**REQUEST FOR CORRECTION OF INFORMATION**

**THE STATE OF KANSAS, THE STATE OF NEBRASKA,  
THE ENERGY FUTURE COALITION, and URBAN AIR INITIATIVE**

**EPAct/V2/E-89 FUEL EFFECTS STUDY**

**MOTOR VEHICLE EMISSIONS SIMULATOR MODEL (MOVES2014)**

**Figure 2. See Exhibit D, at D-2.**

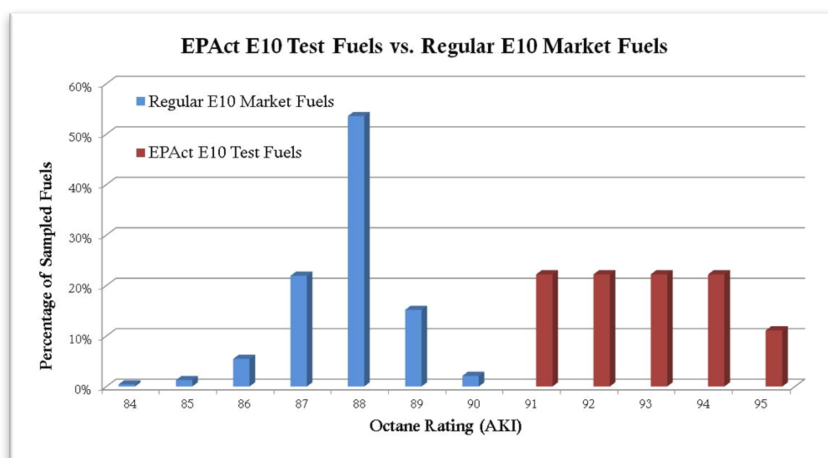
Because it ignored this well-known real-world refinery practice to satisfy its arbitrary match-blending methodology, the EPAAct study’s test fuels contained unrealistically high levels of octane. All of the E10 test fuels, for example, had octane ratings in the range of 90.6 to 94.7 AKI—far above the combined market average of

88.3 AKI.<sup>165</sup> See Figure 2. The test fuels' octane ratings are closer to (though on average they still exceed) the octane ratings of premium fuel,<sup>166</sup> which represents just 10% of all fuel sales.<sup>167</sup>

These octane ratings did not span the range found in the market. Indeed, the octane ratings of some test fuels exceeded the highest ratings found in any market fuel—regular or premium.<sup>168</sup> No test fuel approached the low end of the octane range of market fuel—84.20 AKI.

Figure 3. See Exhibit C, at C-4.

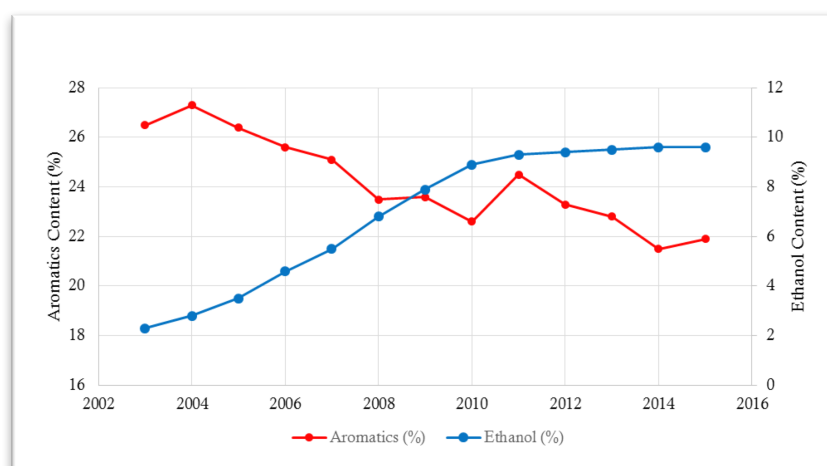
The test fuels' high octane ratings are unrealistic. Barring some regulatory action to establish a minimum octane rating, increasing the ethanol content of gasoline beyond E10 should only further reduce the octane levels of the blendstock as refiners respond to economic incentives to produce lower volumes of the high-boiling-point hydrocarbons used to raise octane levels in the absence of ethanol.<sup>169</sup> See Figure 3.

**Figure 4. See Exhibit C, at C-3.**

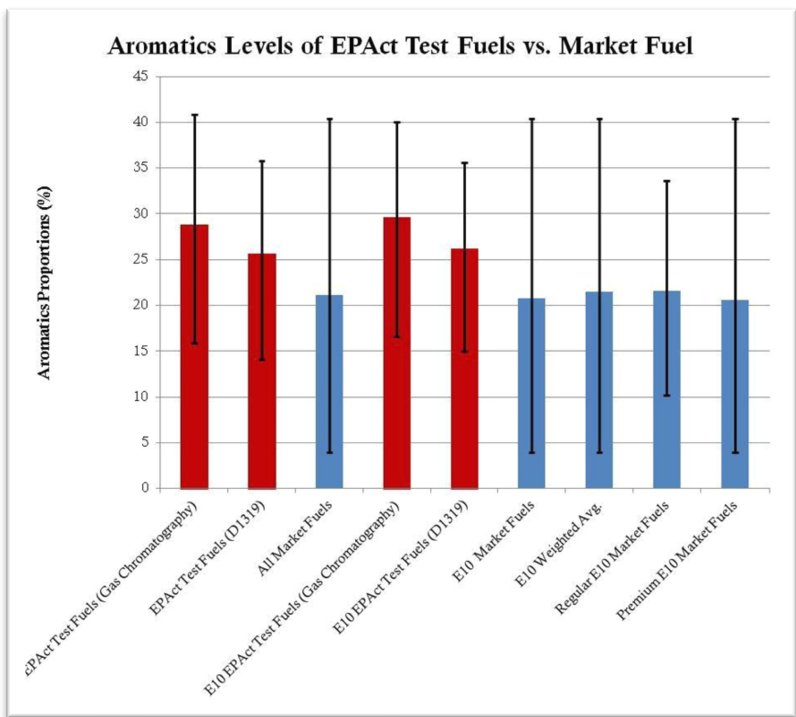
The aromatics levels of the E Pact test fuels also fell short of the study’s aspiration to “span the ranges of in-use fuel properties.”<sup>181</sup> Each test fuel included between 14.1% and 35.8% aromatics.<sup>182</sup> But the market includes fuels with aromatics levels as low as 3.9%. Because the aromatics levels in the test fuel matrix are skewed high, the average aromatics content of the E Pact test fuels was much

higher (25.6%) than the market average (21.1%).<sup>183</sup> See Figure 4.

Figure 5. See Exhibit G, at G-4.

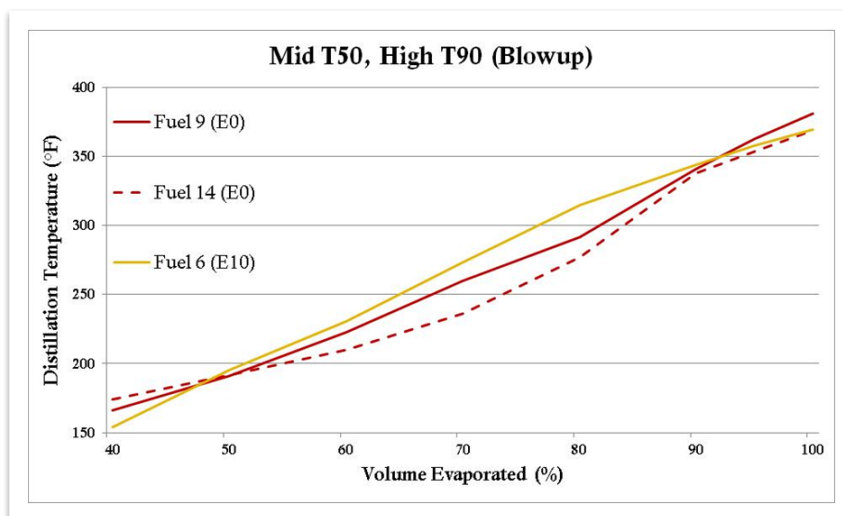
See, e.g., Figure 5. For two of the E10 test fuels (Fuels 10 and 12), the T70 values exceeded the highest levels reported in the national market fuel survey conducted by the Auto Alliance in 2006 (270°F).<sup>203</sup> Two E15 test fuels (Fuels 26 and 27) and three E20 test fuels (Fuels 23, 25, and 31) also have T70 values above that level.<sup>204</sup>

**Figure 6. See Exhibit H, at H-1.**

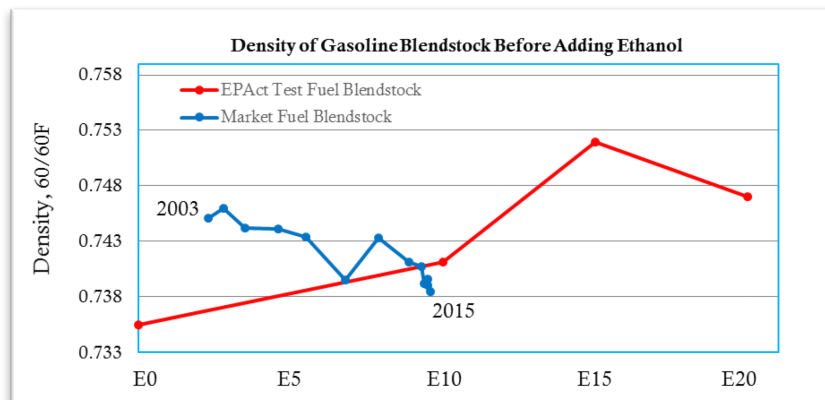
In the market, ethanol displaces higher density octane additives. Thus, refiners historically have lowered the density of the gasoline blendstock as the volume of ethanol to be blended into that gasoline has risen.<sup>215</sup> The EPA Act test fuels invert this market trend: test fuels with more ethanol were generally more dense, not

less. See Figure 6. This demonstrates the lengths to which EPA and its consultants had to go to achieve their arbitrarily matched fuel parameters—adding high-density fuel components to cancel out ethanol’s beneficial reduction of T50 and T90.

Figure 7. See Exhibit I, at I-1.

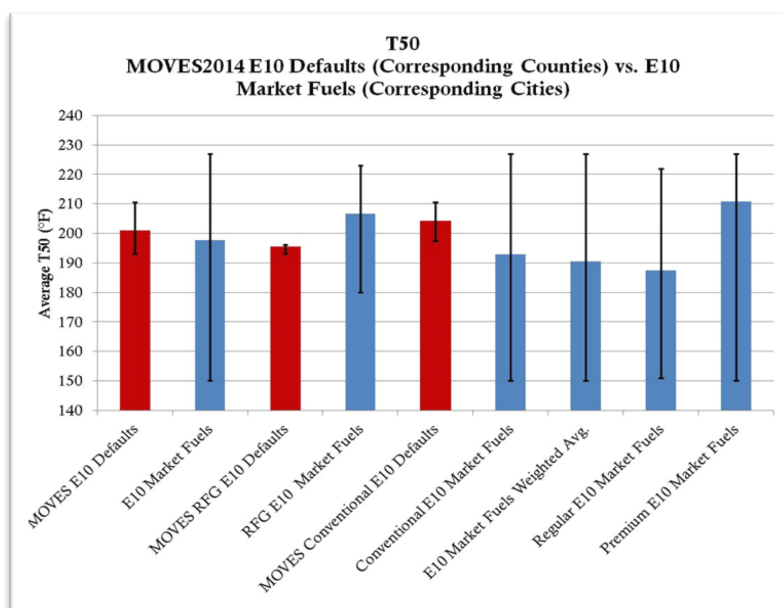
MOVES2014’s default T50 values, for example, are generally higher than those of real-world fuel in corresponding counties.<sup>346</sup> But this basic discrepancy masks an even more fundamental error in the model’s default parameters: In the real world, reformulated gasoline (RFG) tends to have a *higher* T50 boiling point than conventional (non-RFG) gasoline.<sup>347</sup> This is because the lower vapor pressure (RVP) required in RFG demands the addition of low-volatility, high-boiling-point hydrocarbons. But the MOVES2014 defaults reverse this relationship without explanation. The model assumes that RFG has significantly *lower* T50 than conventional fuels,<sup>348</sup>—the exact opposite of what occurs in the real world.<sup>349</sup> See Figure 7.

Figure 8. See Exhibit I, at I-2.

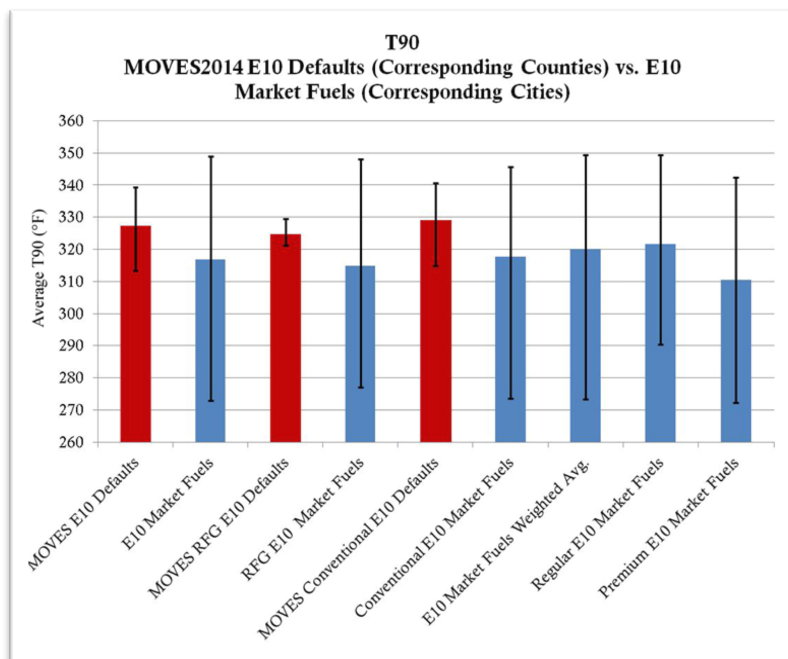
In the case of T90, the average MOVES2014 defaults (327.3°F) are significantly *higher* than the corresponding market averages for both RFG (314.9°F) and conventional gasoline (317.7°F).<sup>350</sup> See Figure 8.

This mismatch between real-world fuel parameters and MOVES2014's assumptions undermines the reliability of its results. Accurate fuel parameters are essential to the proper functioning of MOVES2014. The model cannot provide accurate results unless "the accompanying changes in fuel properties with increasing ethanol content . . . are properly taken into account in the model (e.g. reduced T50, T90, and aromatics)."<sup>351</sup> As with the EPA Act study, "consideration of single coefficients in isolation can easily result in misleading conclusions."<sup>352</sup>
